GRUMMAN AIRCRAFT ENGRG CORP., BETHPAGE, L. I., NEW YORK

SIZE	CODE IDENT NO.		
B	26512	LDW280-51608	A

NAS 9-1100

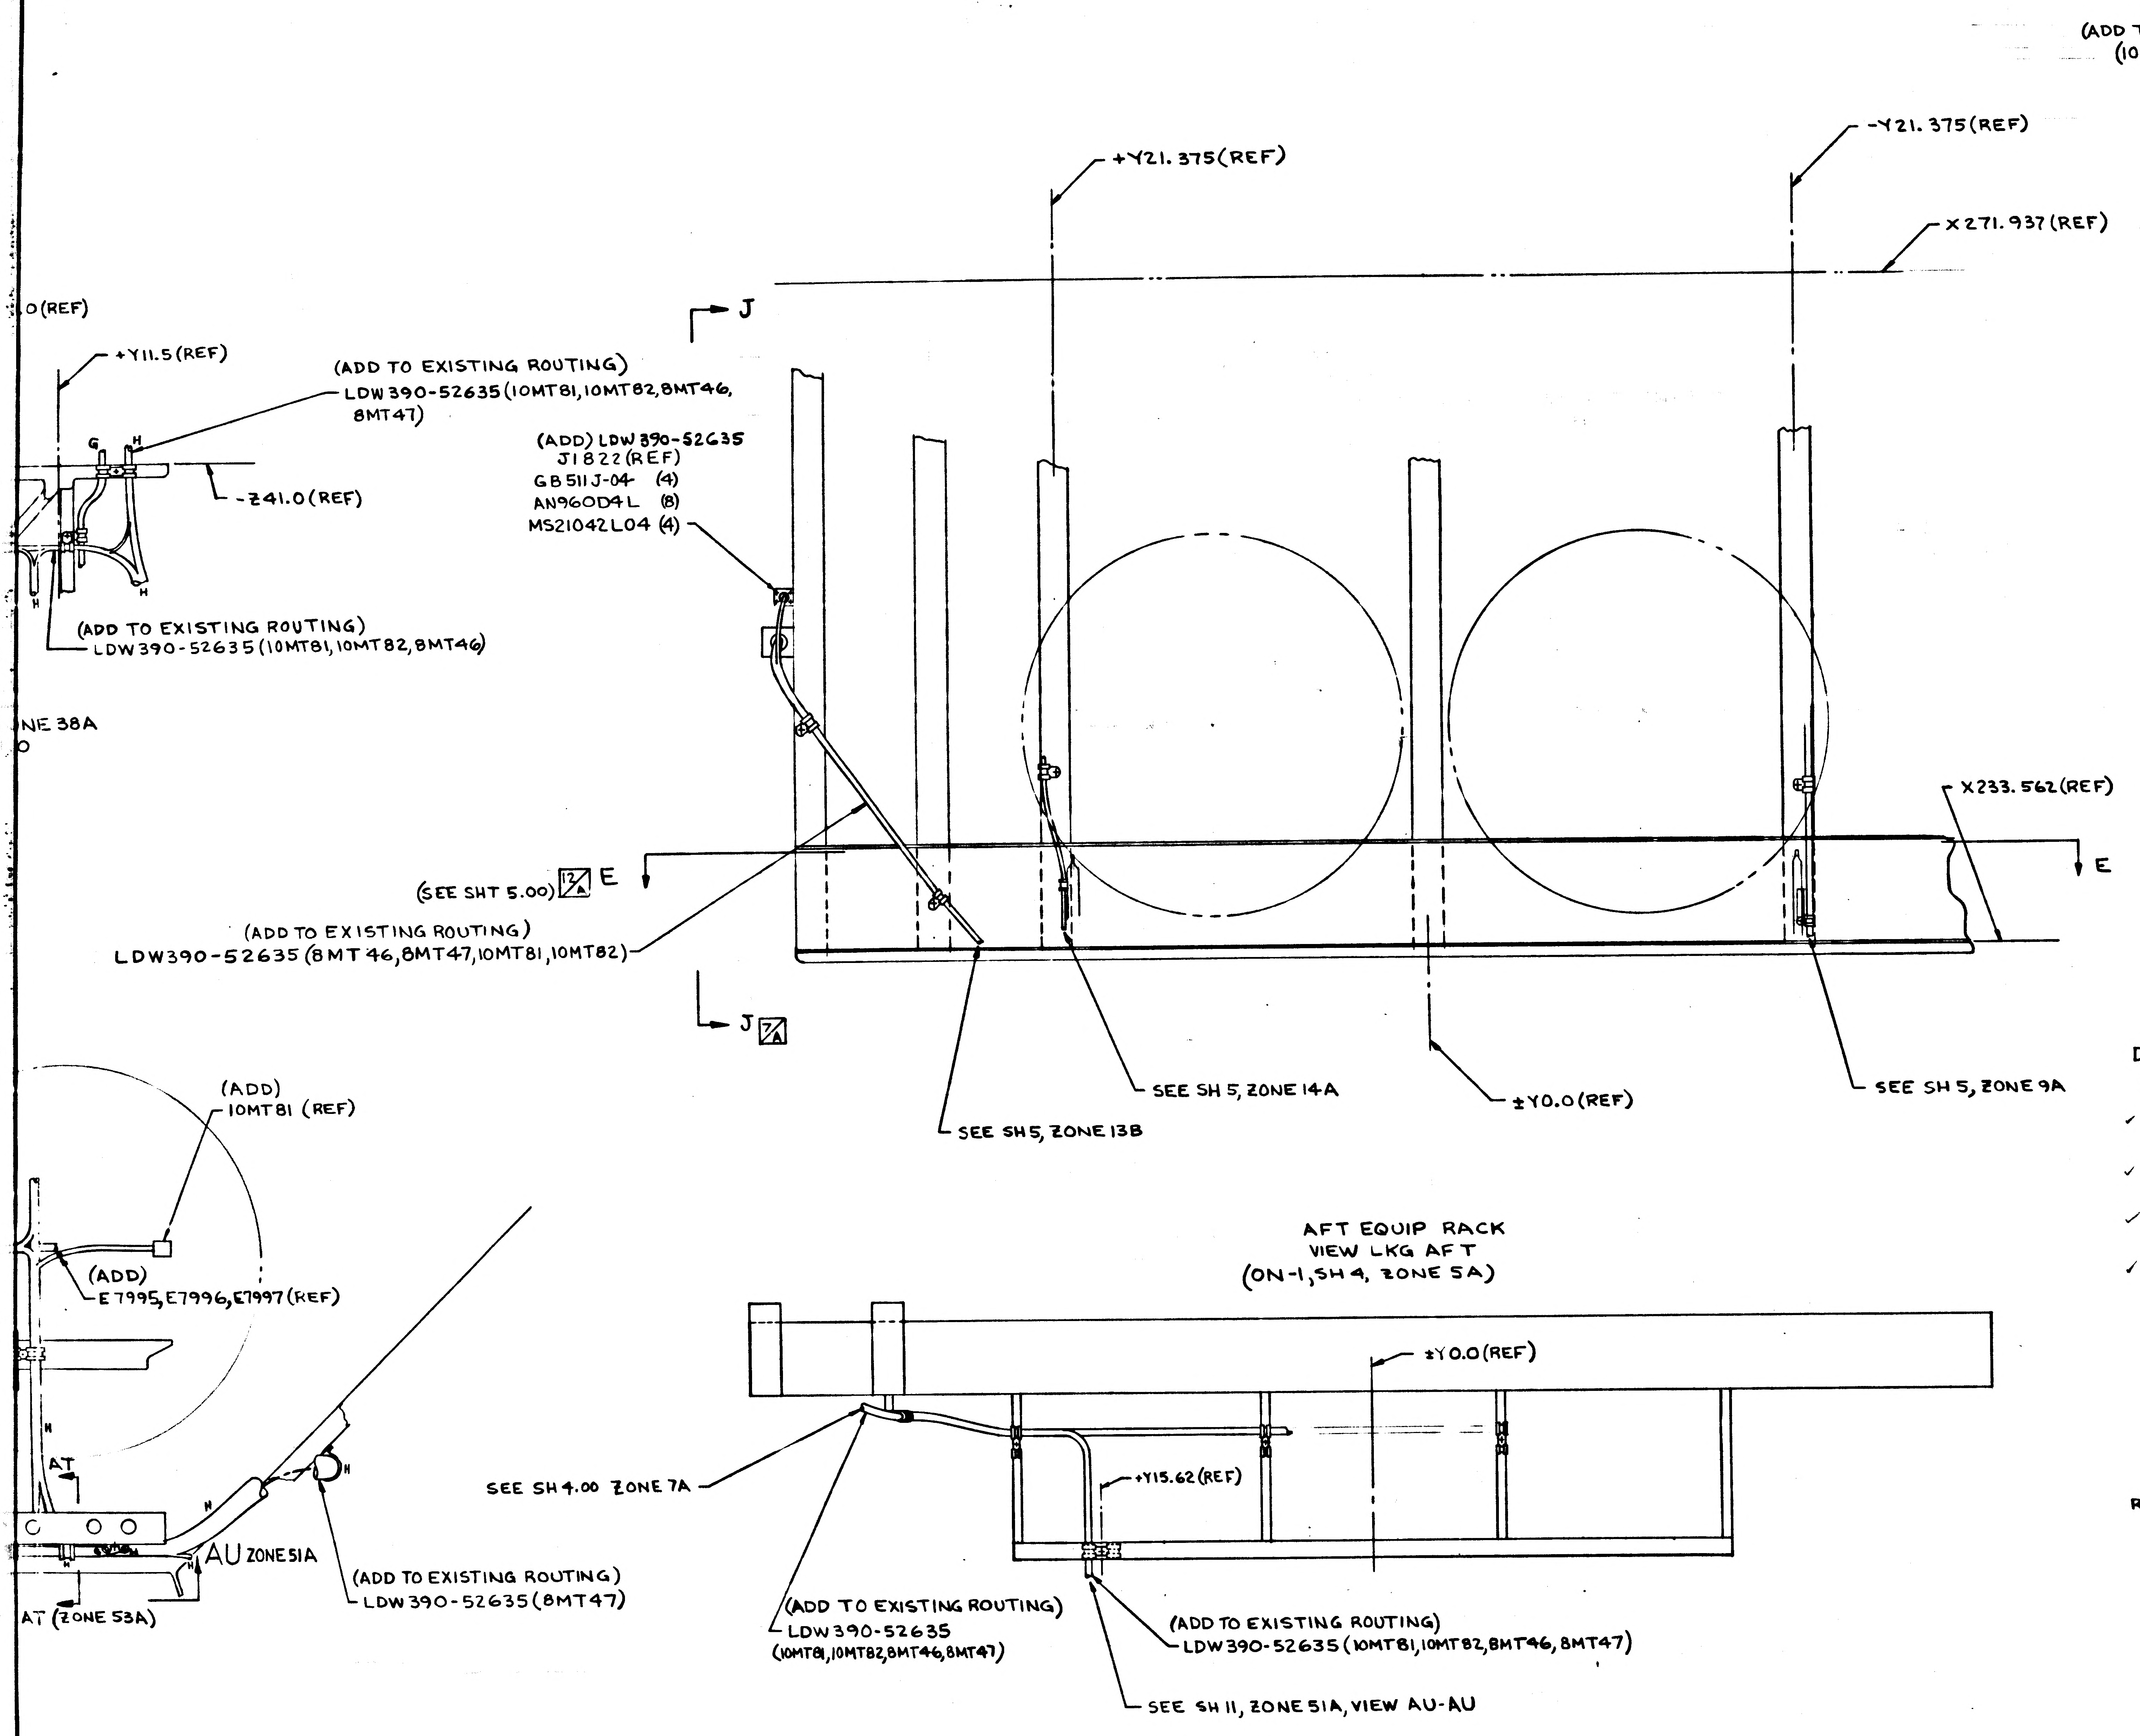
.0(REF)
+Y11.5(REF)
(ADD TO EXISTING ROUTING)
LDW390-52635(10MT81,10MT82,8MT46,
8MT47)
G
H
-Z41.0(REF)
H
H
(ADD TO EXISTING ROUTING)
LDW390-52635(10MT81,10MT82,8MT46)
NE 38A
(ADD) LDW390-52635
J1822(REF)
GB511J-04 (4)
AN960D4L (8)
MS21042L04 (4)
J
+Y21.375(REF)
-Y21.375(REF)
X271.937(REF)
X233.562(REF)
(SEE SHT 5.00) 12/A E
E
(ADD TO EXISTING ROUTING)
LDW390-52635(8MT46,8MT47,10MT81,10MT82)
J 7/A
SEE SH5, ZONE 13B
SEE SH 5, ZONE 14A
±Y0.0(REF)
SEE SH 5, ZONE 9A
(ADD)
10MT81 (REF)
(ADD)
E7995,E7996,E7997(REF)
H
AT
H
AU ZONE 51A
AT (ZONE 53A)
(ADD TO EXISTING ROUTING)
LDW390-52635(8MT47)
SEE SH 4.00 ZONE 7A
±Y0.0(REF)
+Y15.62(REF)
(ADD TO EXISTING ROUTING)
LDW390-52635
(10MT81,10MT82,8MT46,8MT47)
(ADD TO EXISTING ROUTING)
LDW390-52635(10MT81,10MT82,8MT46,8MT47)
SEE SH 11, ZONE 51A, VIEW AU-AU

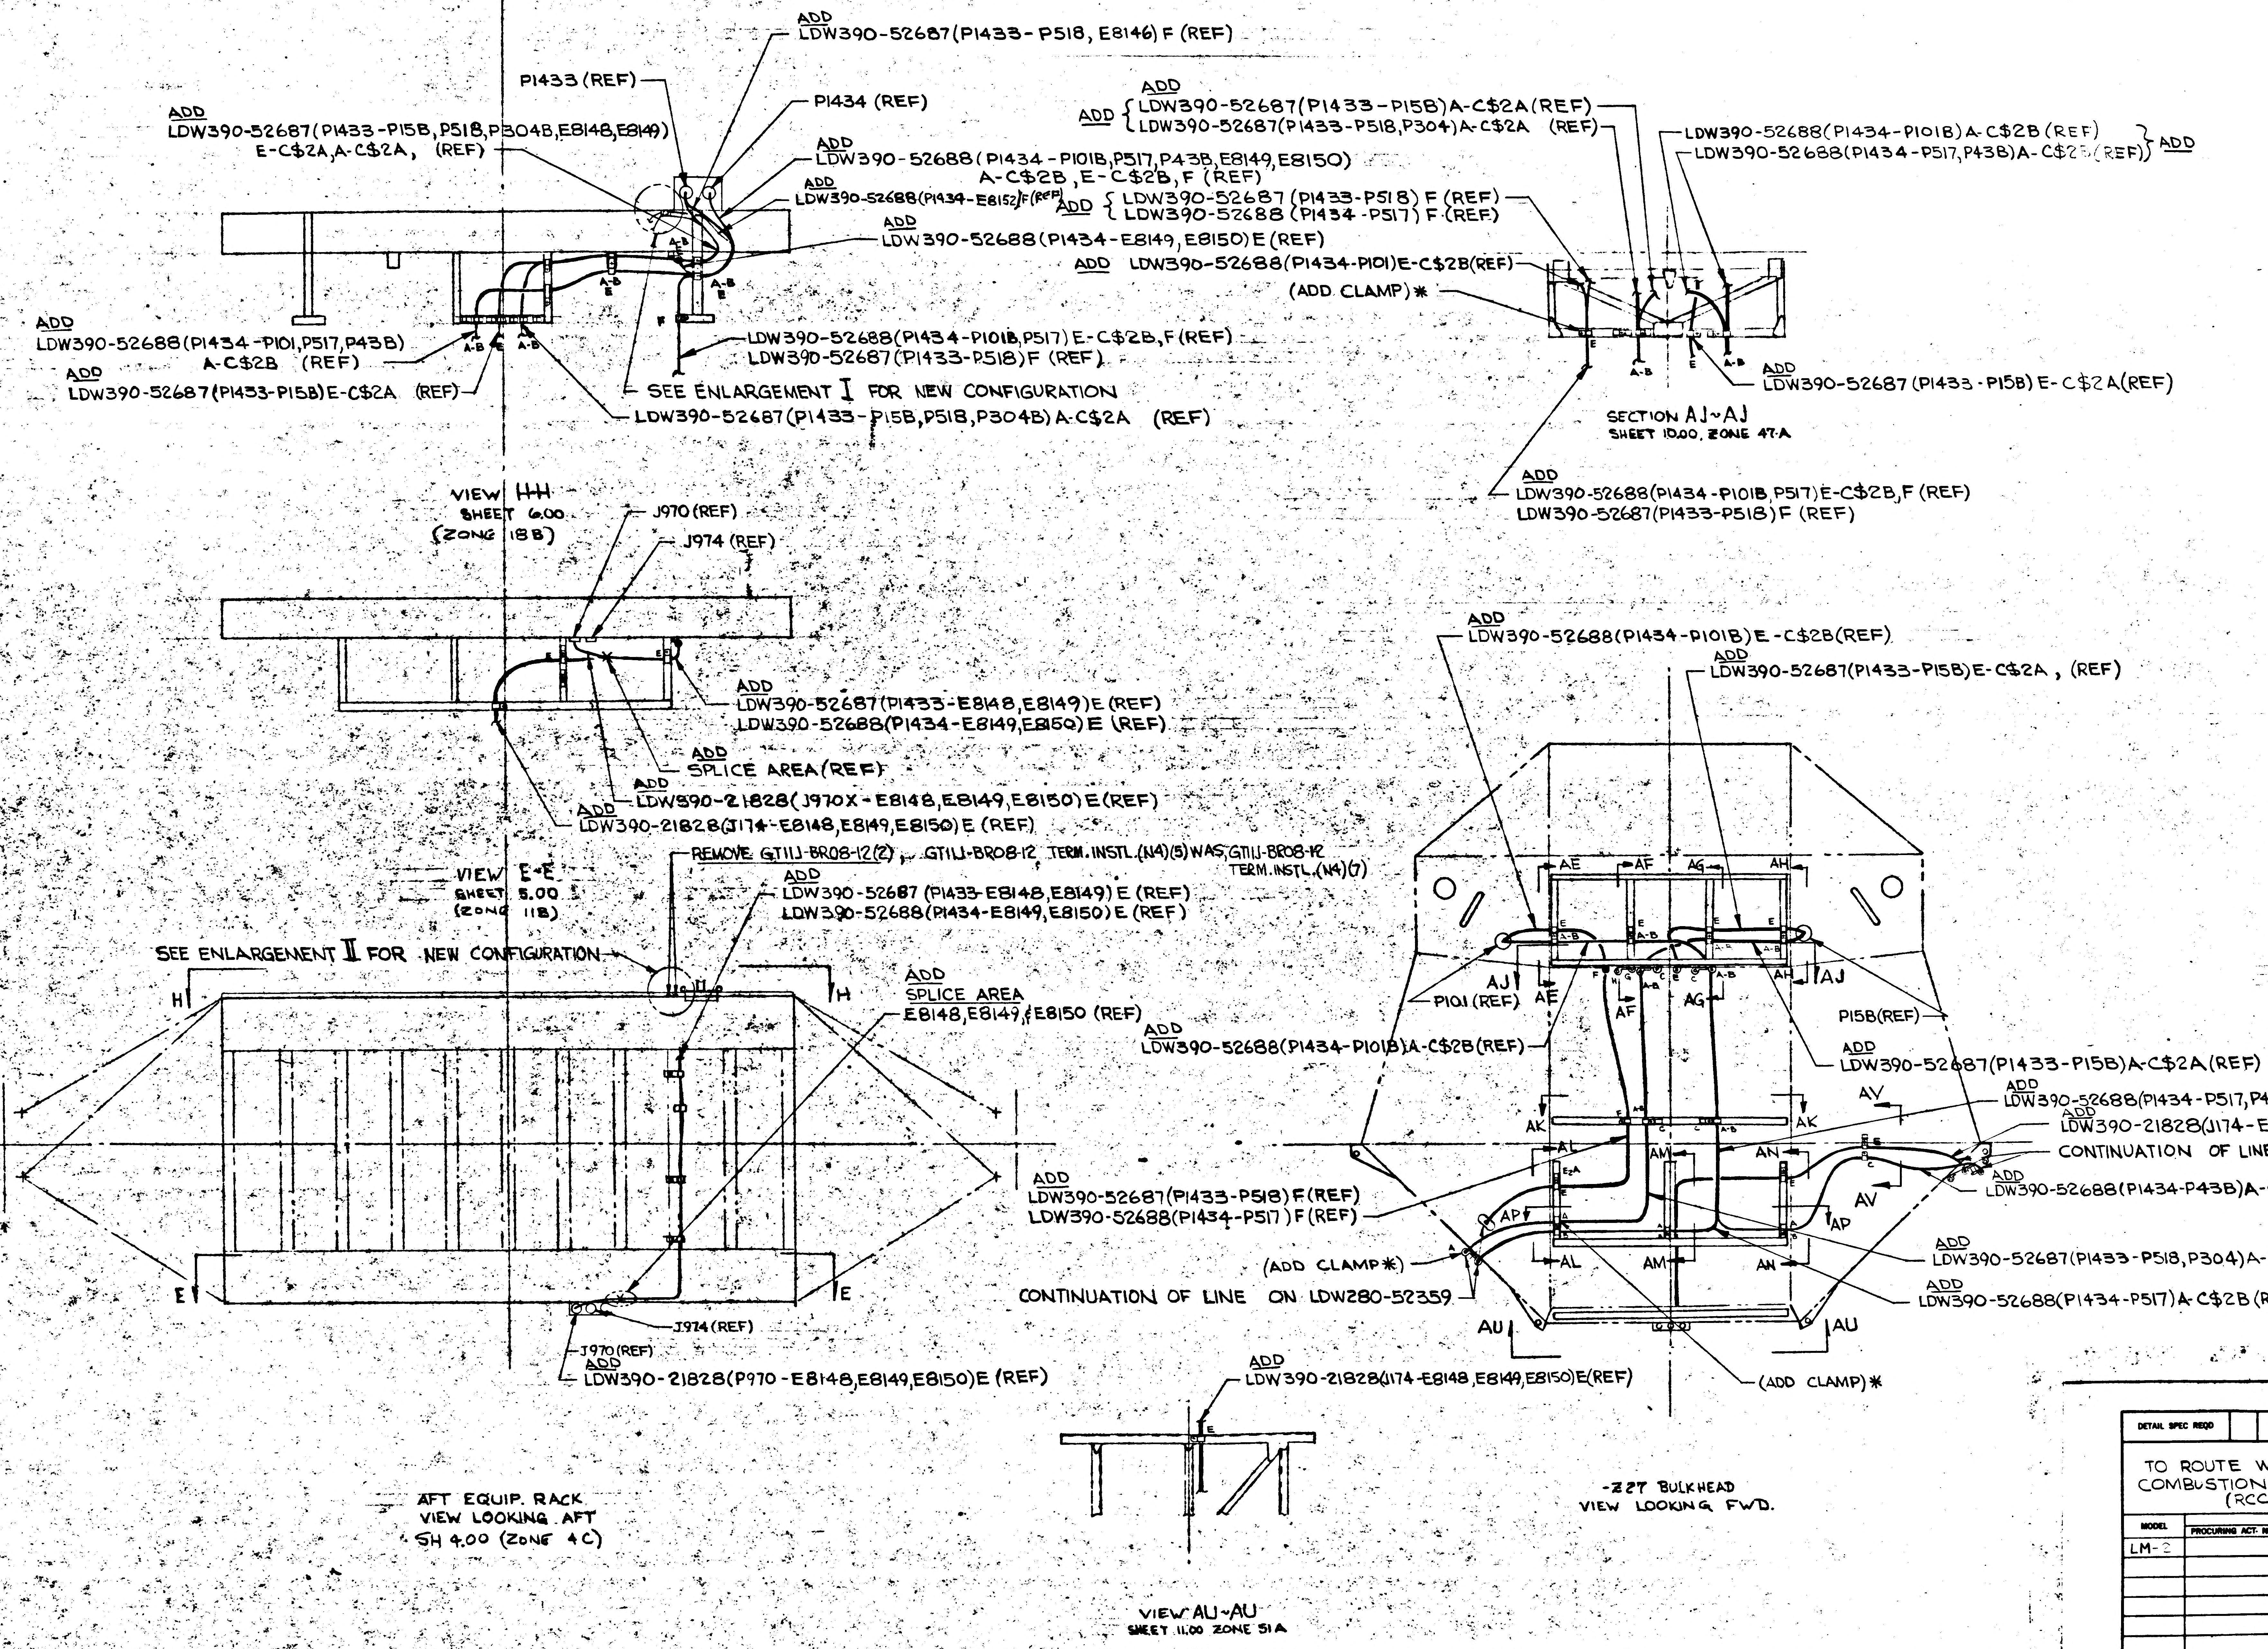
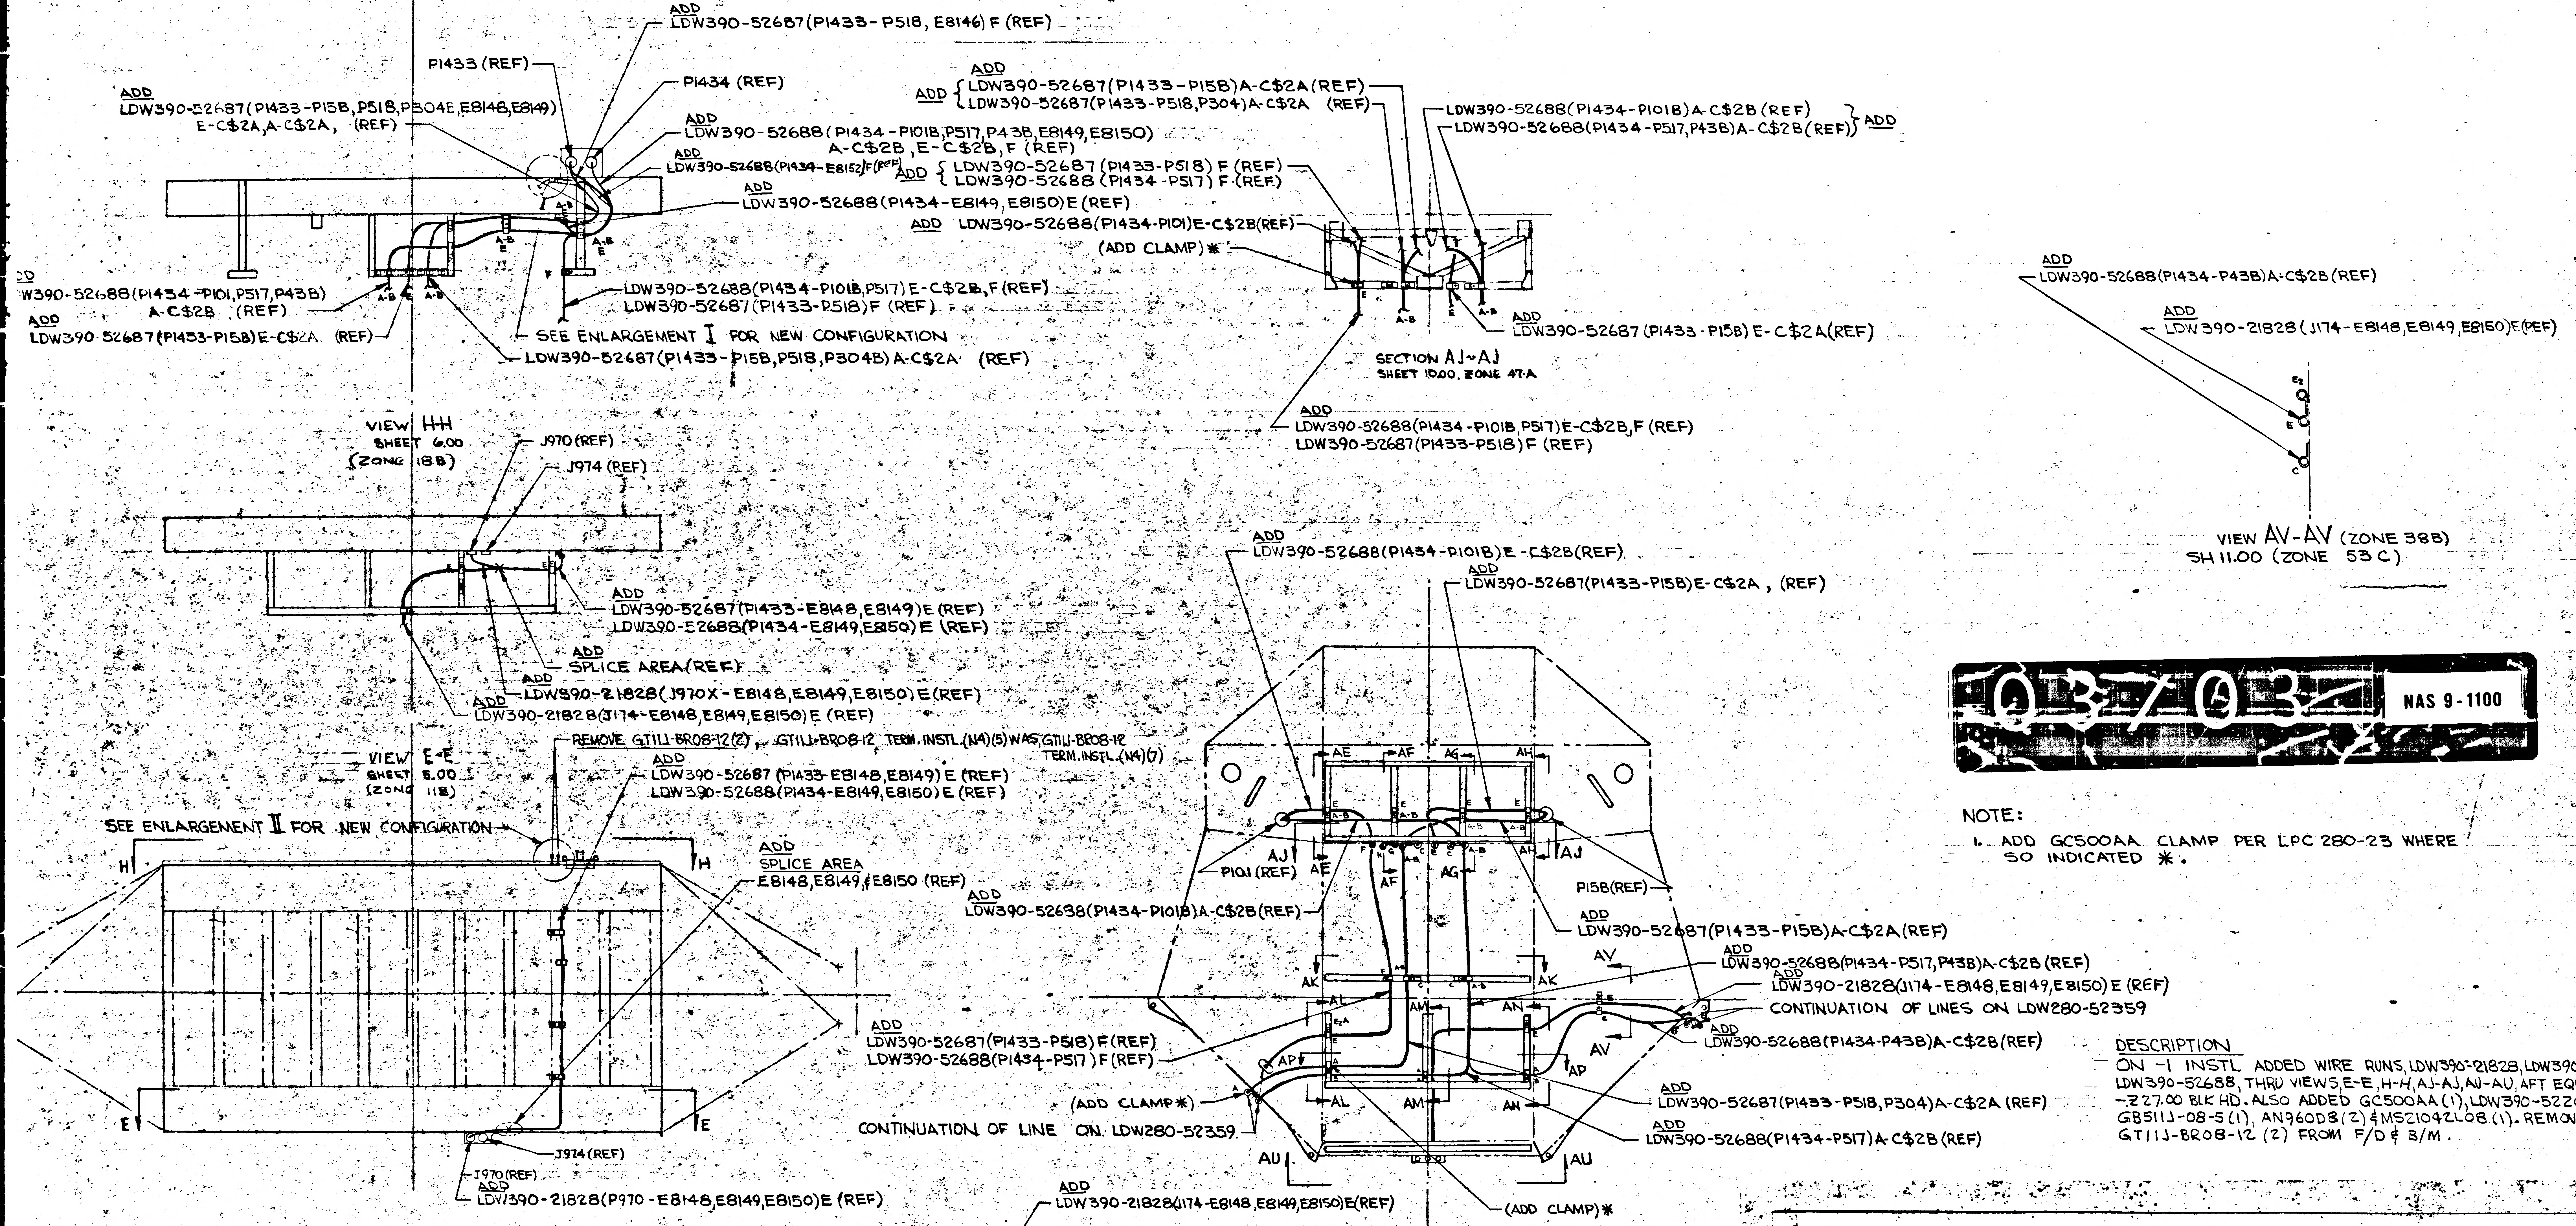
ADD
LDW390-52687(P1433-P518, E8146) F (REF)
P1433 (REF)
P1434 (REF)
ADD
LDW390-52687(P1433-P15B,P518,P304B,E8148,E8149)
E-C$2A,A-C$2A, (REF)
ADD
LDW390-52688(P1434-P101B,P517,P43B,E8149,E8150)
A-C$2B,E-C$2B,F (REF)
ADD
LDW390-52688(P1434-E8152)F(REF)
ADD
LDW390-52688(P1434-E8149,E8150)E(REF)
ADD
LDW390-52688(P1434-P101,P517,P43B)
A-C$2B (REF)
ADD
LDW390-52687(P1433-P15B)E-C$2A (REF)
LDW390-52688(P1434-P101B,P517)E-C$2B,F(REF)
LDW390-52687(P1433-P518)F (REF)
SEE ENLARGEMENT I FOR NEW CONFIGURATION
LDW390-52687(P1433-P15B,P518,P304B)A-C$2A (REF)
A-B
E
F
ADD
ADD { LDW390-52687(P1433-P15B)A-C$2A(REF)
LDW390-52687(P1433-P518,P304)A-C$2A (REF)
ADD { LDW390-52687 (P1433-P518) F (REF)
LDW390-52688 (P1434-P517) F (REF)
ADD LDW390-52688(P1434-P101)E-C$2B(REF)
(ADD CLAMP)*
LDW390-52688(P1434-P101B)A-C$2B (REF)
LDW390-52688(P1434-P517,P43B)A-C$2B(REF) } ADD
ADD
LDW390-52687 (P1433-P15B) E-C$2A(REF)
SECTION AJ~AJ

ADD
LDW390-52687(P1433-P518, E8146) F (REF)
P1433 (REF)
P1434 (REF)
ADD
LDW390-52687(P1433-P15B,P518,P304E,E8148,E8149)
E-C$2A,A-C$2A, (REF)
ADD
LDW390-52688 (P1434-P101B,P517,P43B,E8149,E8150)
A-C$2B ,E-C$2B, F (REF)
ADD
LDW390-52688(P1434-E8152)F(REF)
ADD
LDW390-52688(P1434-E8149, E8150) E (REF)
ADD
LDW390-52688(P1434-P101,P517,P43B)
A-C$2B (REF)
ADD
LDW390-52687(P1433-P15B)E-C$2A (REF)
A-B
E
F
LDW390-52688(P1434-P101B,P517) E-C$2B,F (REF)
LDW390-52687(P1433-P518)F (REF)
SEE ENLARGEMENT I FOR NEW CONFIGURATION
LDW390-52687(P1433-P15B,P518,P304B) A-C$2A (REF)
ADD
ADD { LDW390-52687(P1433-P15B)A-C$2A(REF)
LDW390-52687(P1433-P518,P304)A-C$2A (REF)
LDW390-52688(P1434-P101B)A-C$2B (REF)
LDW390-52688(P1434-P517,P43B)A-C$2B(REF) } ADD
ADD { LDW390-52687 (P1433-P518) F (REF)
LDW390-52688 (P1434-P517) F (REF)
ADD LDW390-52688(P1434-P101)E-C$2B(REF)
(ADD CLAMP) *
ADD
LDW390-52687 (P1433-P15B) E-C$2A(REF)
SECTION AJ~AJ
